# XU 10 J4R ENGINE (RFV)

- CYLINDER HEAD R.P.O. 6779 →  
(cylinder head, camshafts, camshaft bearing cap casings)
- TIGHTENING PROCEDURES  
(camshaft bearing cap casings)
- DIPSTICK GUIDE TUBE ASSEMBLY  
R.P.O. 6793 →
- RECIPROCATING GEAR  
R.P.O. 6769 →

## EVOLUTION : XU10J4R ENGINE (RFV)

Fig : B1BP10YP

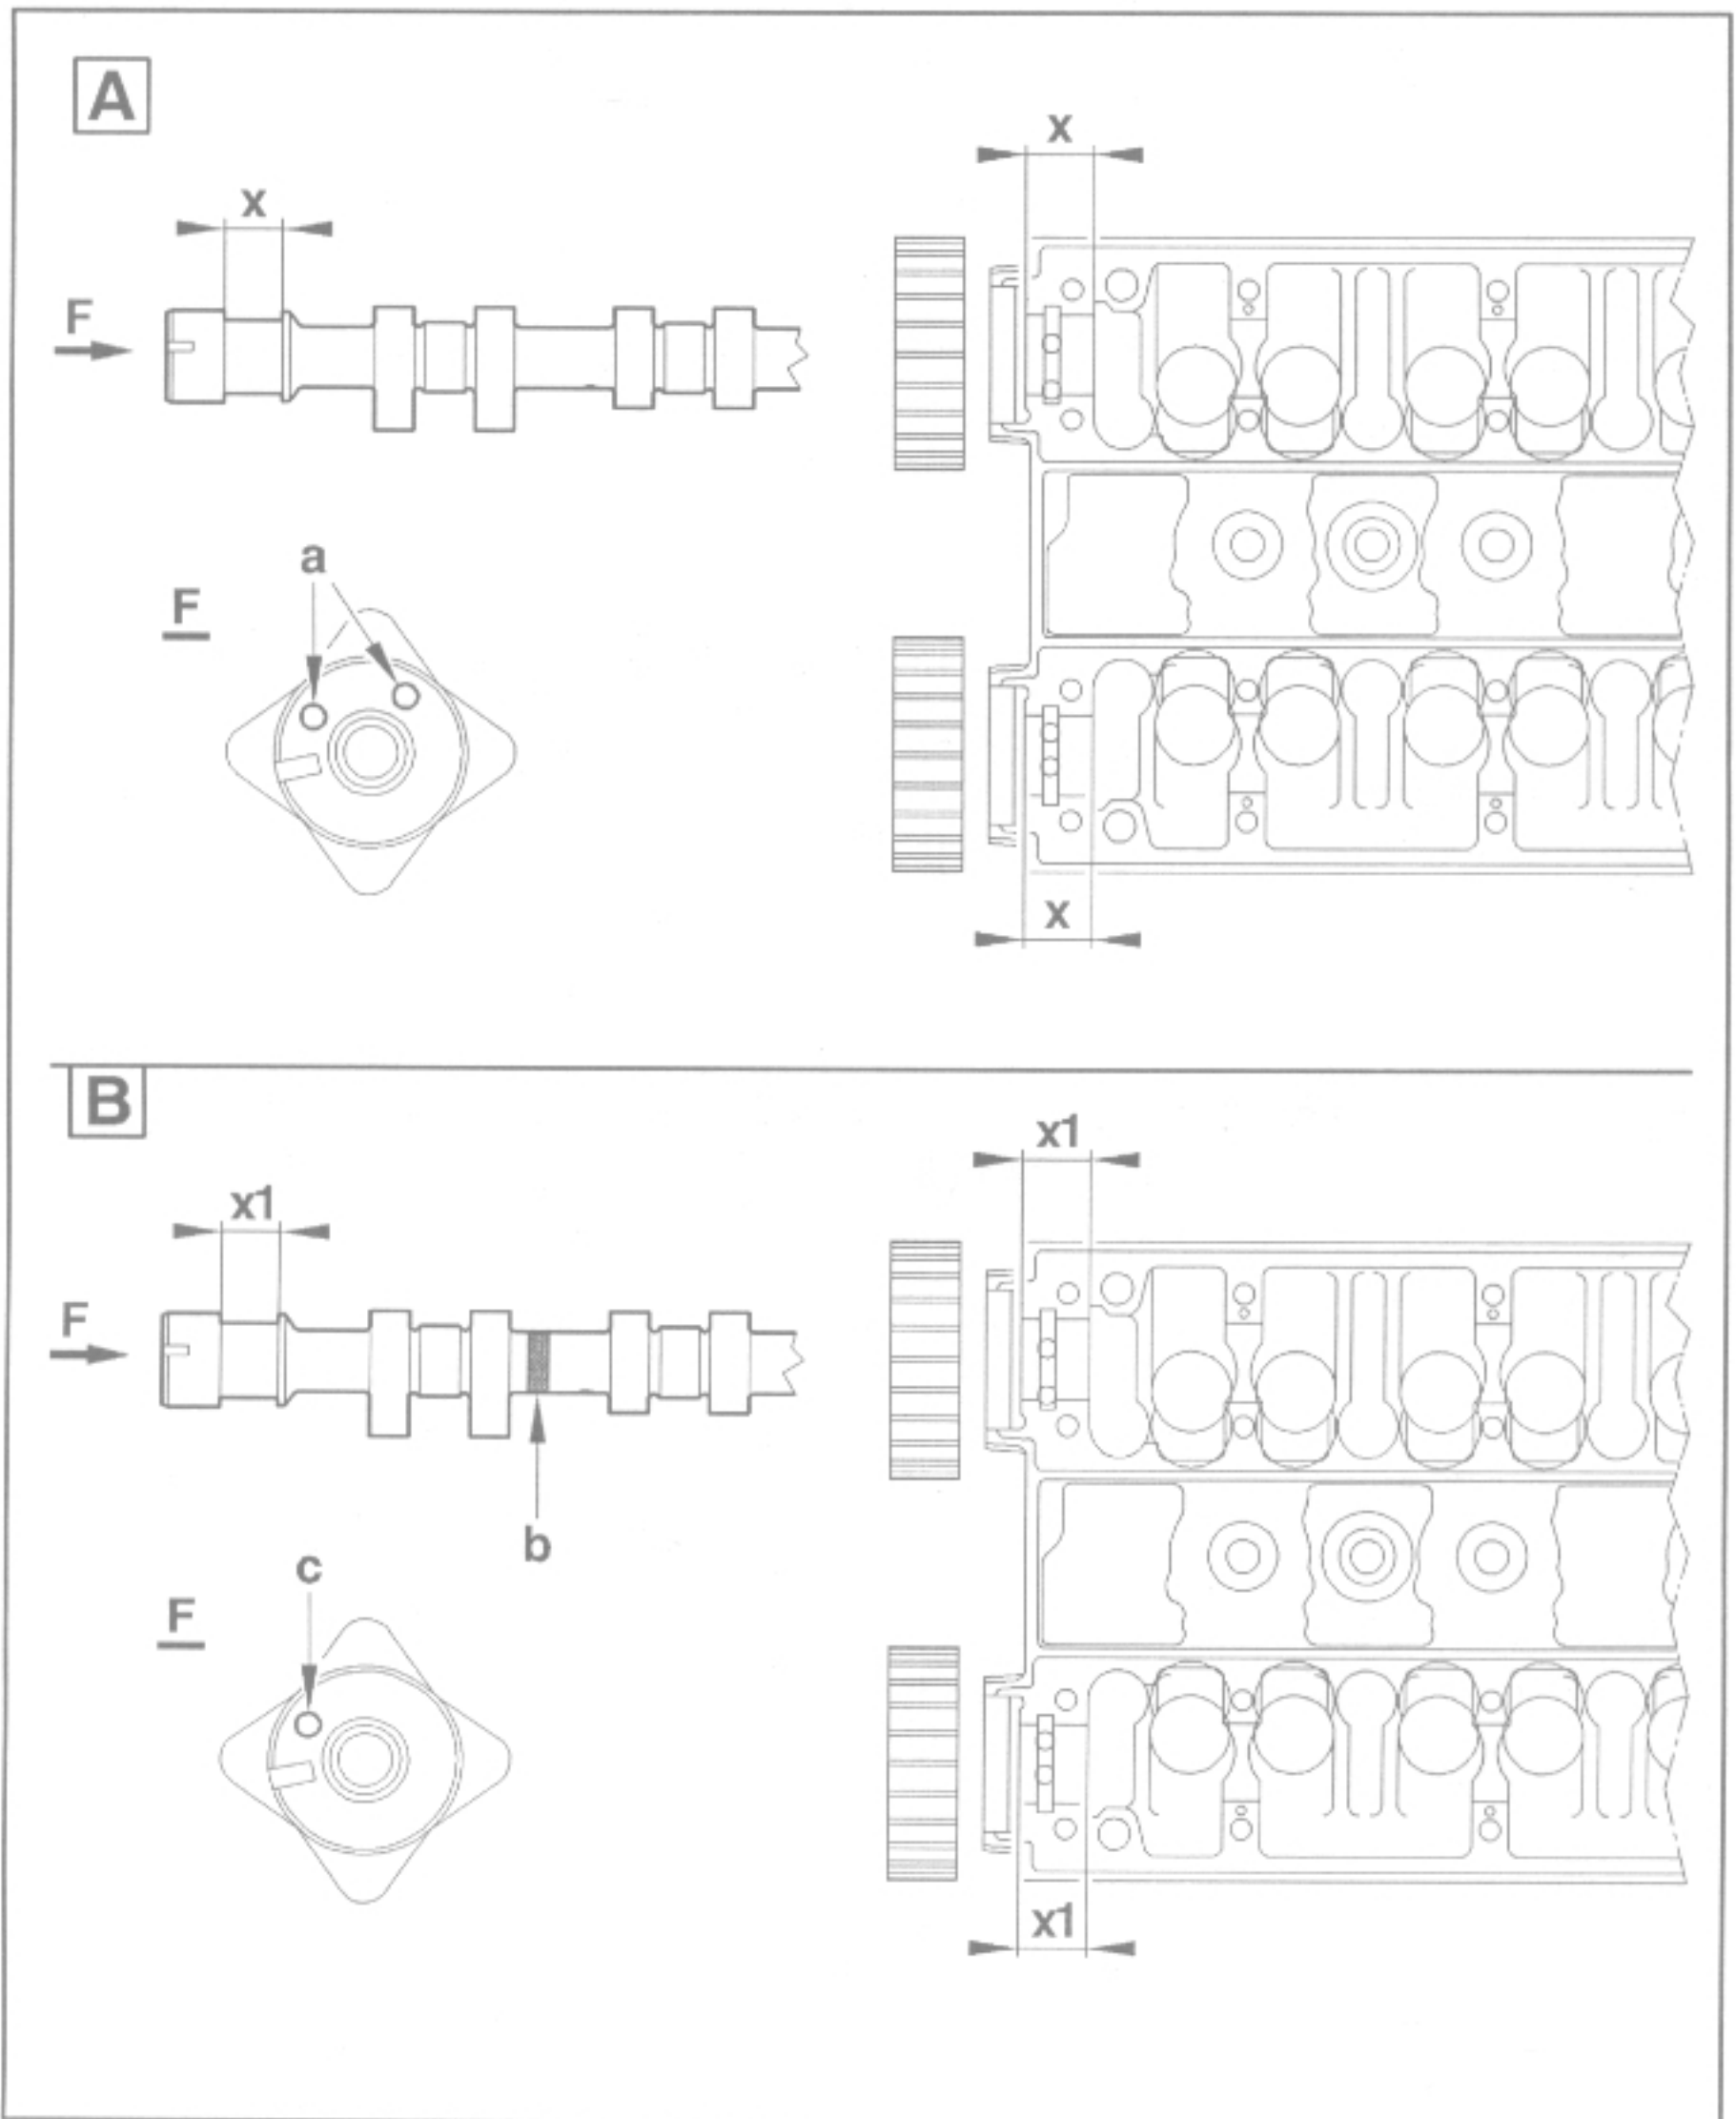
Reduction of width of the camshaft lateral bearing (bearing no. 5, gear side) : 23 mm instead of 24 mm.

Identification of the cylinder head : width of X = 23 mm.

The camshafts : width of X = 23 mm.

Identification of camshafts : 2 holes "a" on valve timing side (view F).

Identification of the cylinder head :  
width of X1 = 24 mm.

The camshafts : width of X1 = 24 mm.

- 1 white paint mark item "b"
- 1 hole "c" (depth 10 mm) on valve timing side (view F)

The parts of the earlier and later assemblies cannot be interchanged separately.

The early engines can be modified if all the new parts are fitted.

Fig : B1BP10ZD

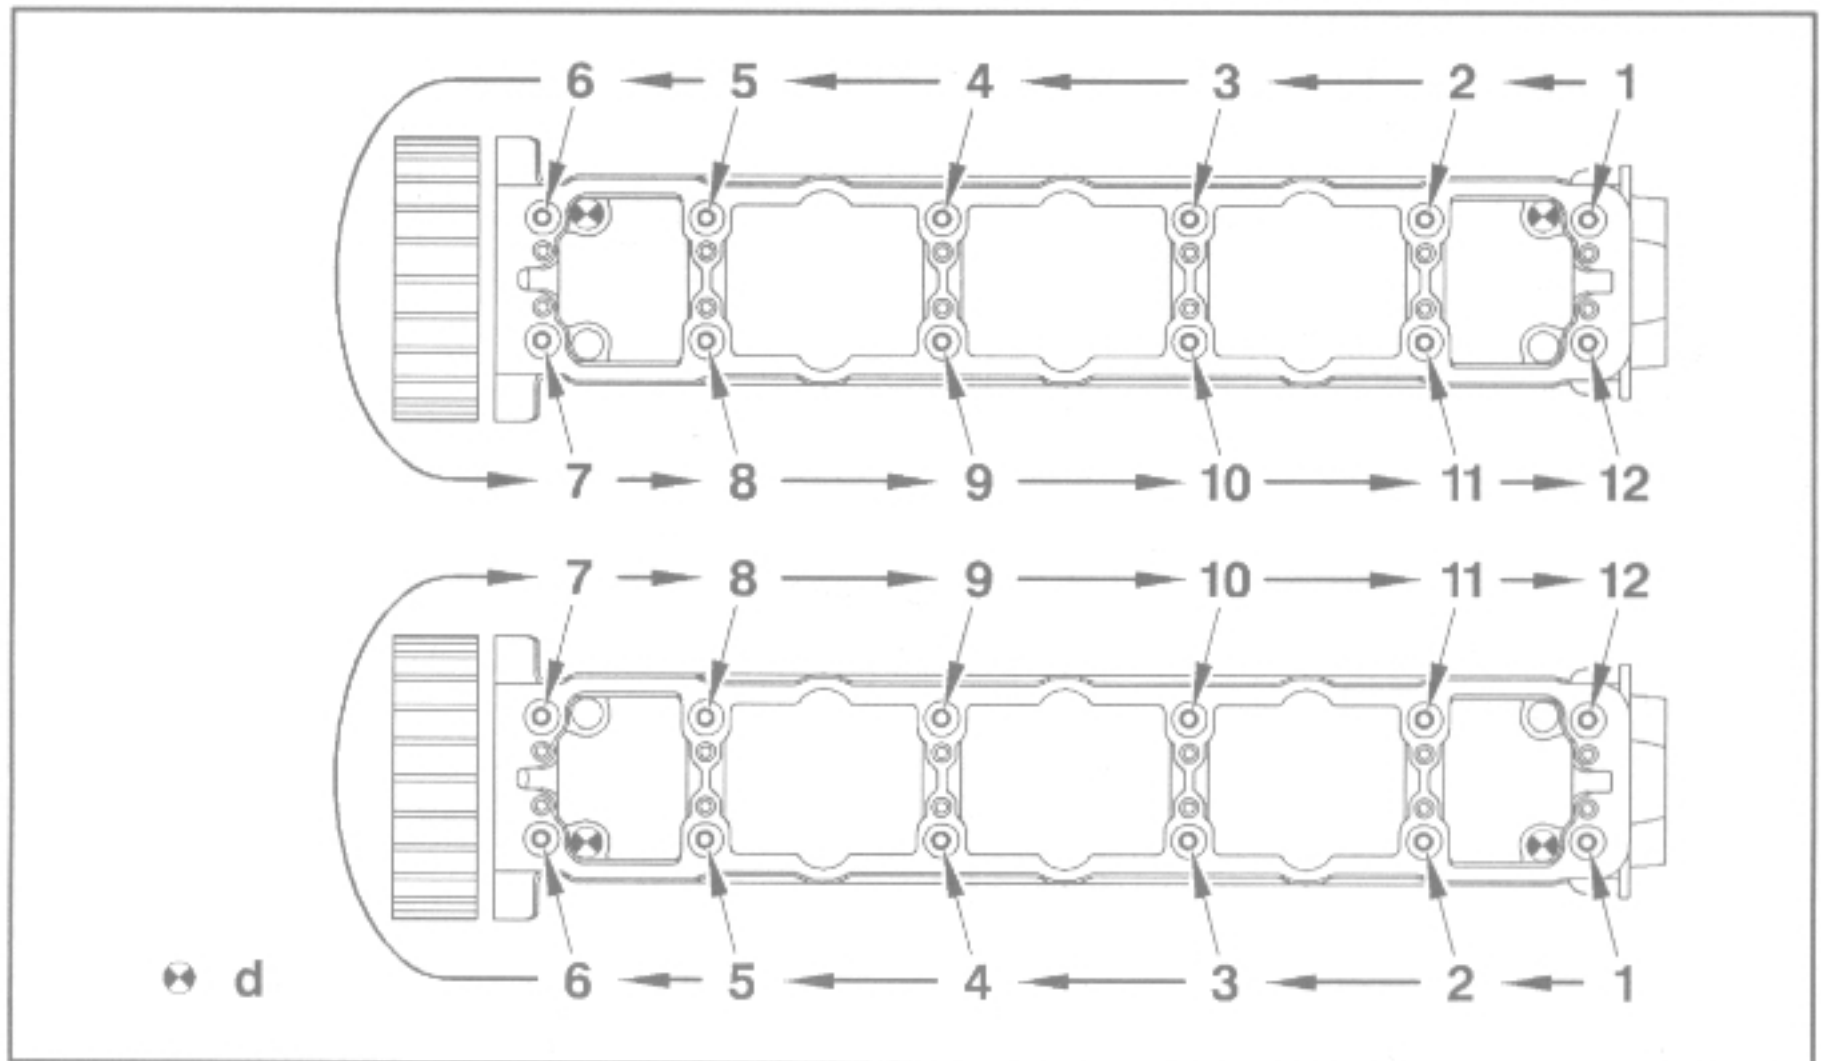
New tightening method : "U" type tightening instead of "snail" type.

Tighten the retaining bolts in the order indicated.

- pre-tighten the screws to 0.5 m.daN
- tighten to 1 m.daN

**IMPERATIVE** : Only this new method should be applied.

Fig : B1BP110C

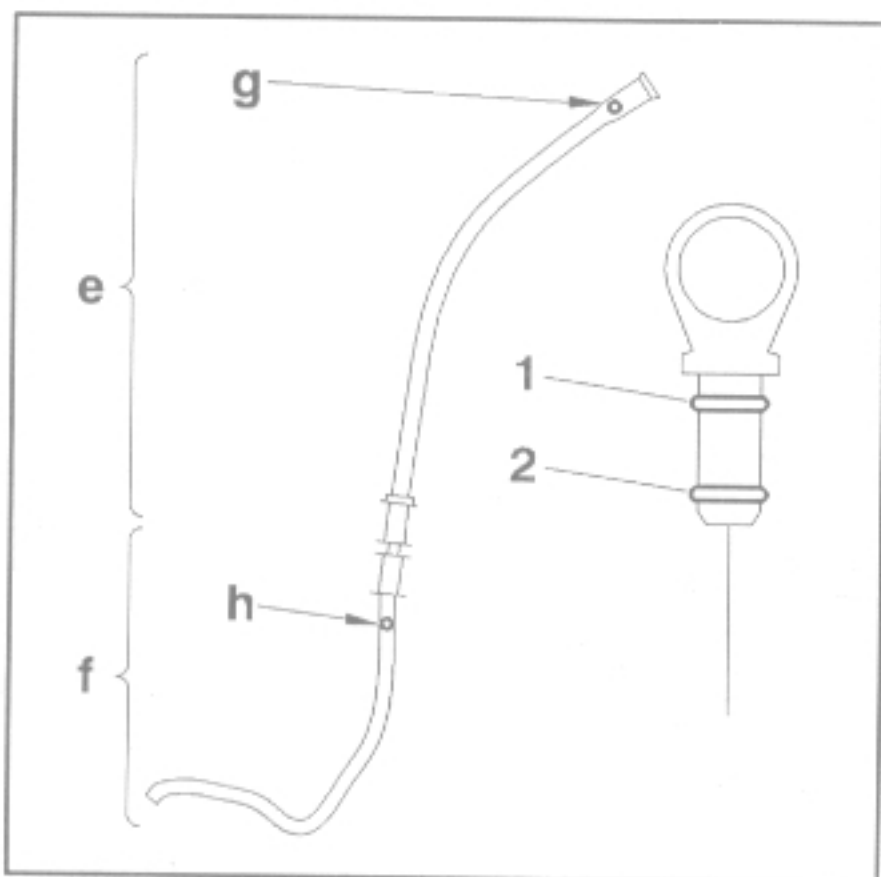
The venting hole has been relocated from position "g" to position "h".

- upper dipstick guide tube "e" (without venting hole at position "g")
- lower dipstick guide tube "f" (with venting hole at position "h")
- dipstick with O-ring (2)

- upper dipstick guide tube "e" (with venting hole at position "g")
- lower dipstick guide tube "f" (without venting hole at position "h")
- dipstick with O-rings (1) and (2)

Diameter of venting holes : 2 mm.

The dipstick guide tubes of both assemblies are not interchangeable.

A dipstick with two seals can be fitted onto either assembly

The fitting of a dipstick with only one seal on former engines is prohibited.

The early engines can only be modified if all the new parts are fitted.

Fig : B1BP111D

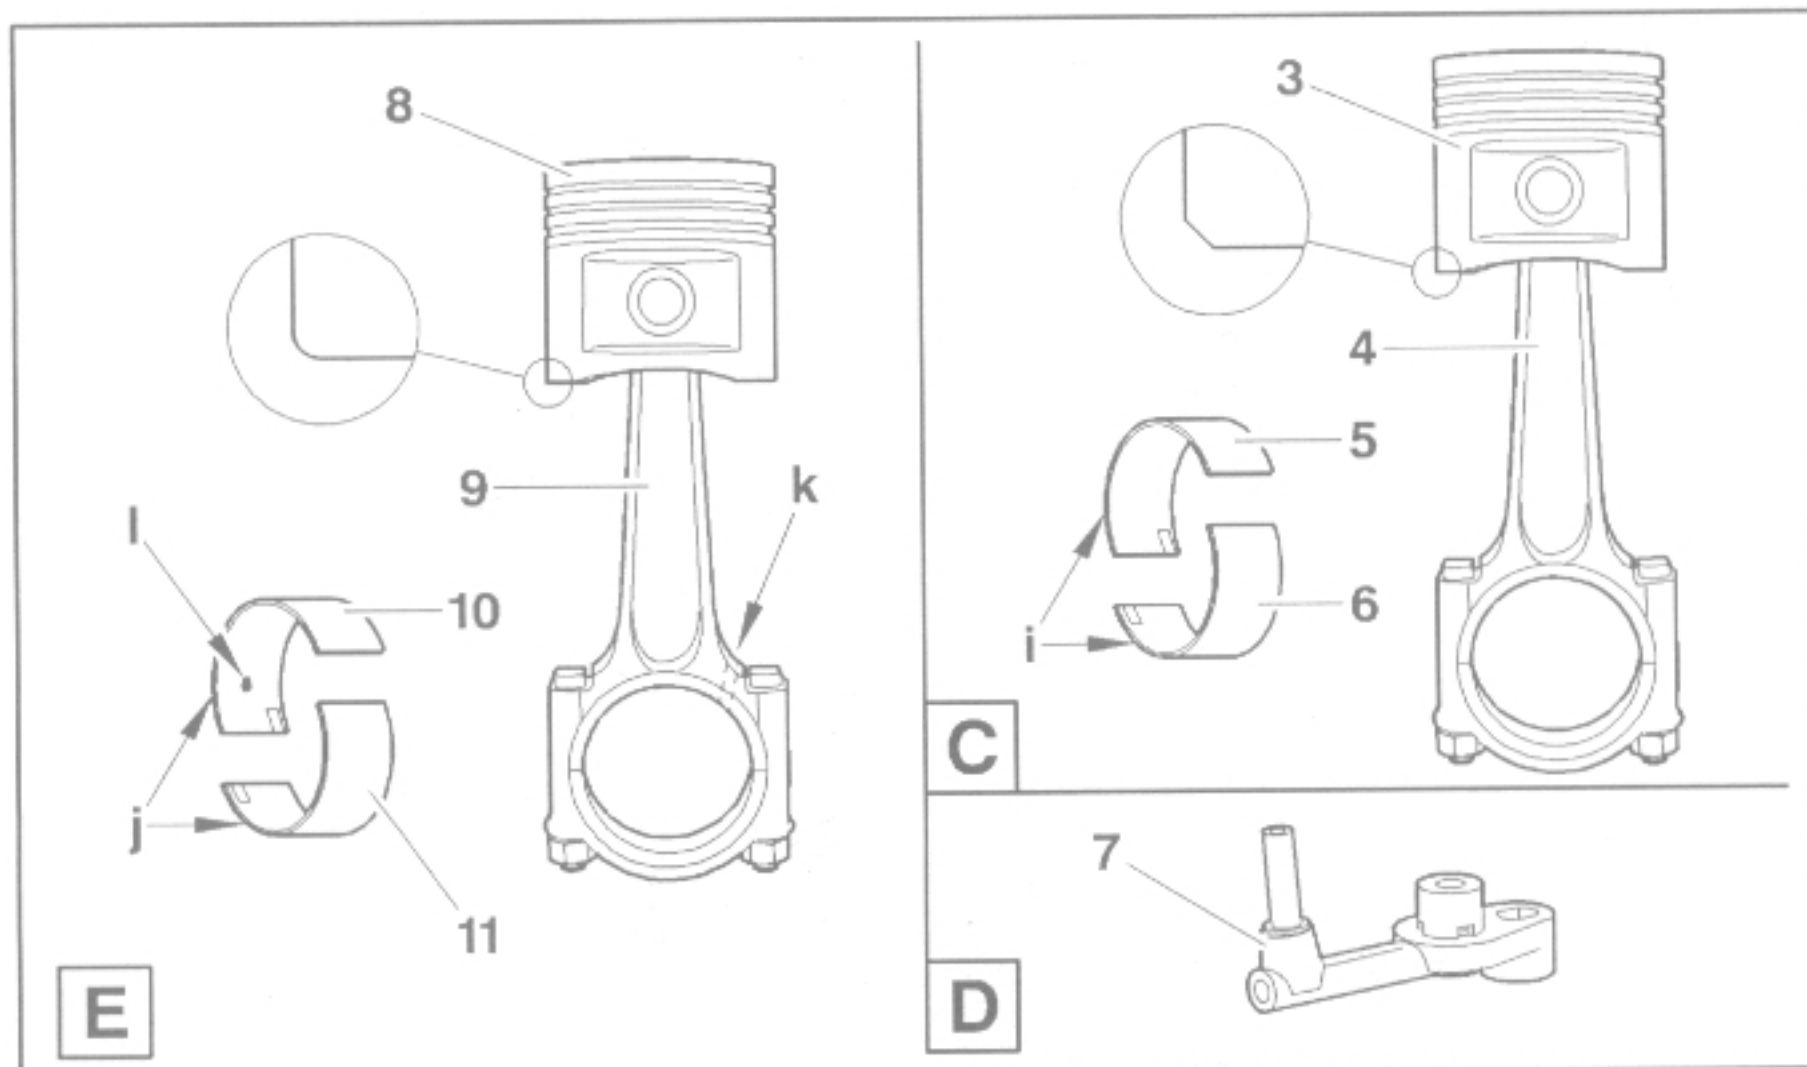
Assembly N°1 : C.

Assembly N°2 : C + D.

Assembly N°3 : E.

- connecting rod, piston, connecting rod bearing halfshell assembly identical to assembly 1
- new cylinder block with nozzles to improve the lubrication of the liners

- new cylinder block (without nozzles), (improved surface condition of cylinders)
- the nozzles are replaced by a drilled connecting rod and upper bearing halfshell assembly
- new pistons, (improved surface condition of the skirt)

The drilled connecting rod bearing halfshells can replace the bearing halfshells without drilling, but the reverse is prohibited.

Fig : B1BP112C

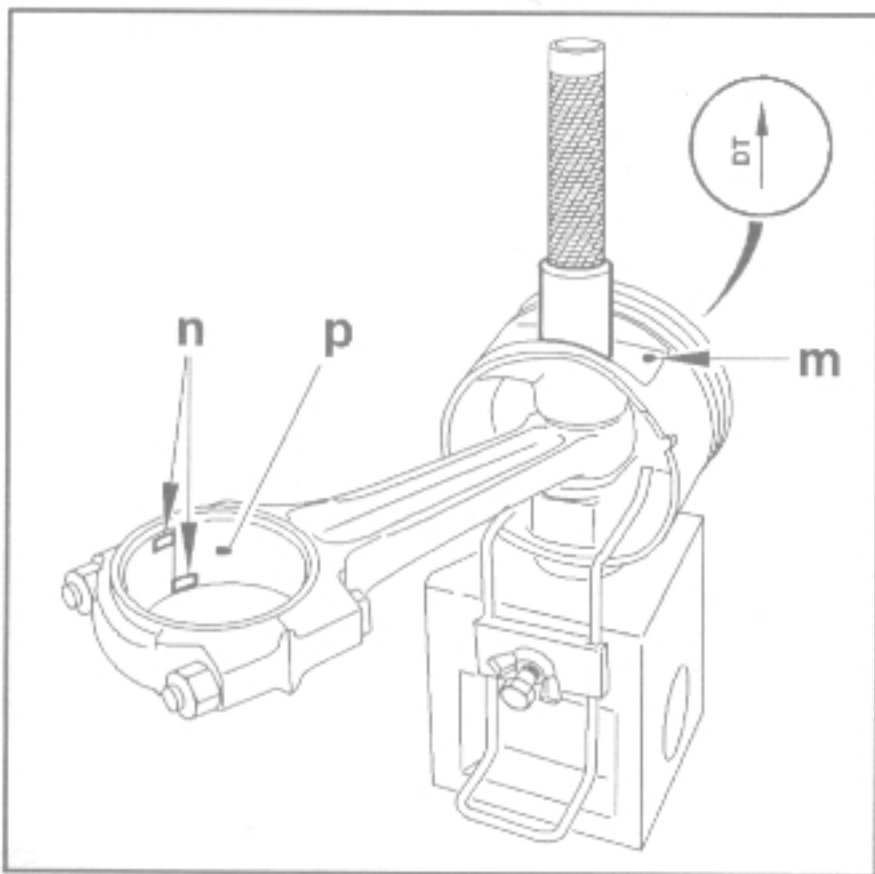
**IMPERATIVE** : Observe the orientation of the connecting rod in relation to the piston.

- arrow "DT" positioned on the upper side
- casting spot "m" positioned on the upper side

Checking the correct positioning of the connecting rod : notches "n" on the left side.

- piston : arrow "DT" pointed towards the valve timing side
- connecting rod : hole "p" directed towards the exhaust side
